SOLICITATION AMENDMENT MODIFICATION DE L'INVITATION

Title - Sujet Reconstruction quai Grande-Entrée	
Solicitation No. - N° de l'invitation F3731-170016/A	Amendment No. - N° modif. 001
Client Reference No. - N° de référence du client F3731-170016	Date 2017-11-29
GETS Reference No. - N° de référence de SEAG PW-\$QCM-008-17263	
File No. - N° de dossier QCM-7-40165 (008)	CCC No./N° CCC - FMS No./N° VME
Solicitation Closes - L'invitation prend fin at - à 02:00 PM on - le 2017-12-08	Time Zone Fuseau horaire Heure Normale du l'Est HNE
F.O.B. - F.A.B. Plant-Usine: <input type="checkbox"/> Destination: <input checked="" type="checkbox"/> Other-Autre: <input type="checkbox"/>	
Address Enquiries to: - Adresser toutes questions à: Rochette, Jean	Buyer Id - Id de l'acheteur qcm008
Telephone No. - N° de téléphone (418) 649-2834 ()	FAX No. - N° de FAX (418) 648-2209
Destination - of Goods, Services, and Construction: Destination - des biens, services et construction:

AMENDEMENT 001

Title: THE DEMOLITION AND RECONSTRUCTION OF WHARVES 401 TO 405 OF THE FISHING HARBOUR OF GRANDE-ENTRÉE IN THE MAGDALEN ISLANDS, QC

Titre: QUESTION #3 (FEUILLE 21/SHEET 21)

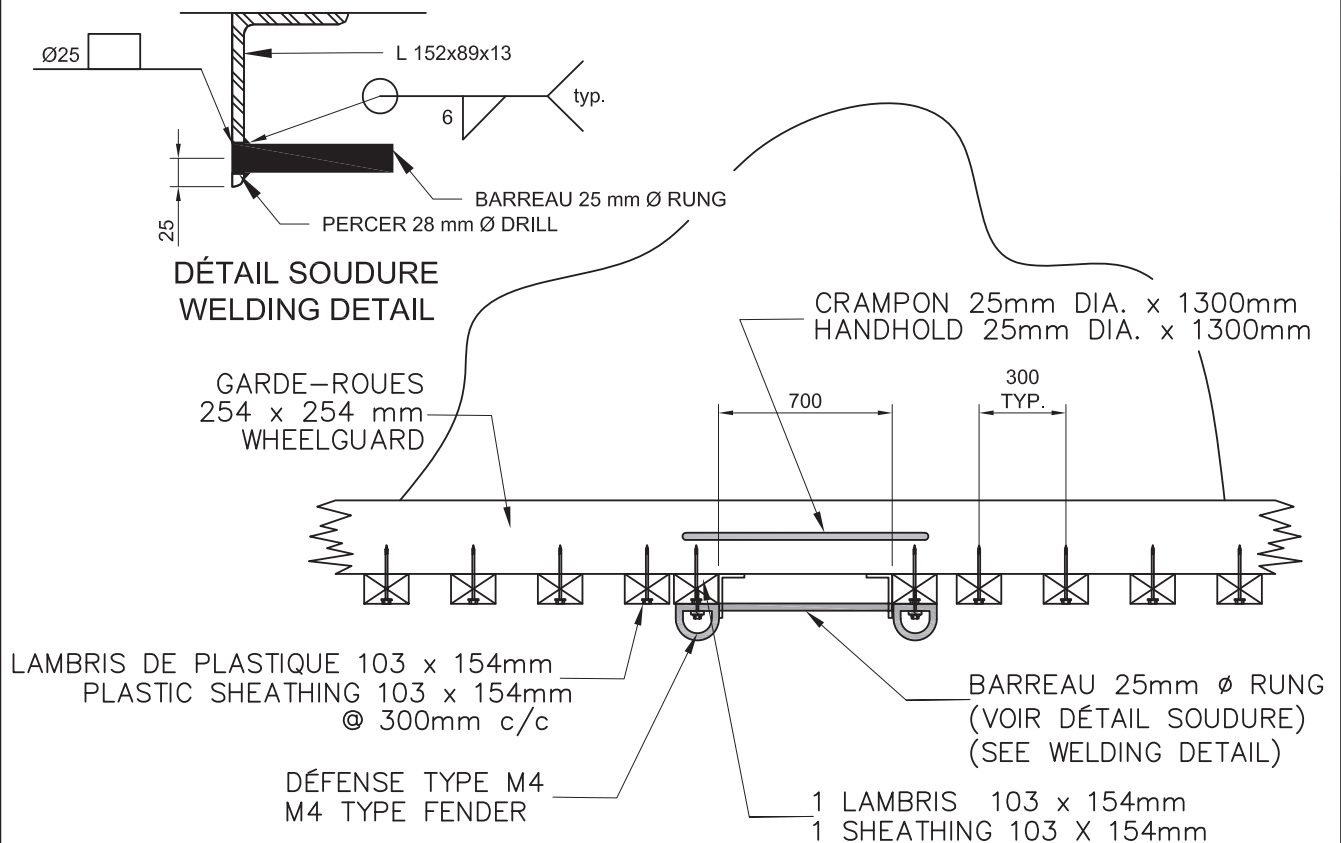
Question 3: Could you complete the details for the manufacture of ladders? It lacks the dimensions of steel angle, the type of steel, fasteners to the dock. If we rely on the drawing, it seems that the rung will be very close to the wall, is this what is desired (the sheathing is only 103 mm thick)?

Answer 3: The missing information is:
-2 L 152 x 89 x 12.7mm lg. req.
-Rungs 25 mm x 700 mm @ 300 mm c / c
-Flat bar 50 mm x 9 lg. Req.
-Handhold 25 mm

The rungs shall be welded in order to leave a maximum space for the foot (see additional details)
